Council Ref: Kincoppal Rose Bay School (HPE CM Folder: SC5907 Ref: 20/241876)
Planning & Development Division

29 January 2021

Application Number SSD-10325
Proposal name Alterations and additions to Kincoppal – Rose Bay School
Address 2 Vaucluse Road, Vaucluse

Figure 1: before and after views to the southern boundary of the subject site. Source BVN report P 56.

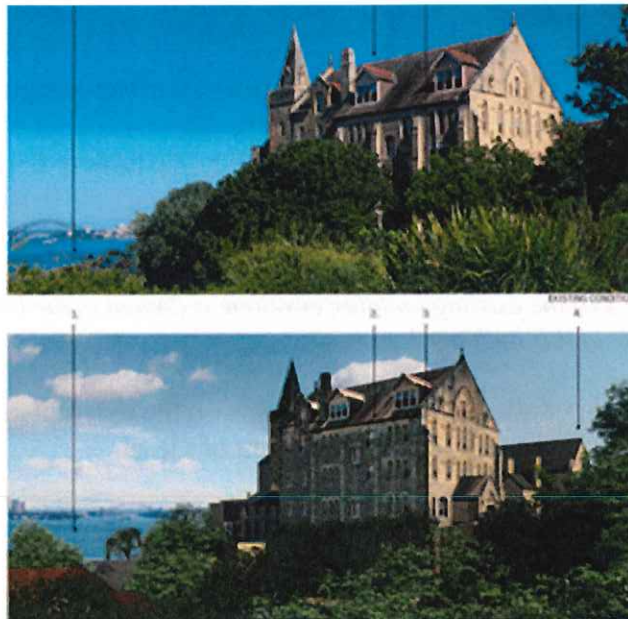
- The proposed bus and car parking area on the southern boundary of the subject site results in the removal of approximately ten existing trees at this location (DWG 01-03 Architectural plans 01). It significantly changes the current soft landscaping character of this location, as shown in Figure 1 below.

The proposed level of change to the existing landscaped character of the subject site is inconsistent with the following principles and objectives:
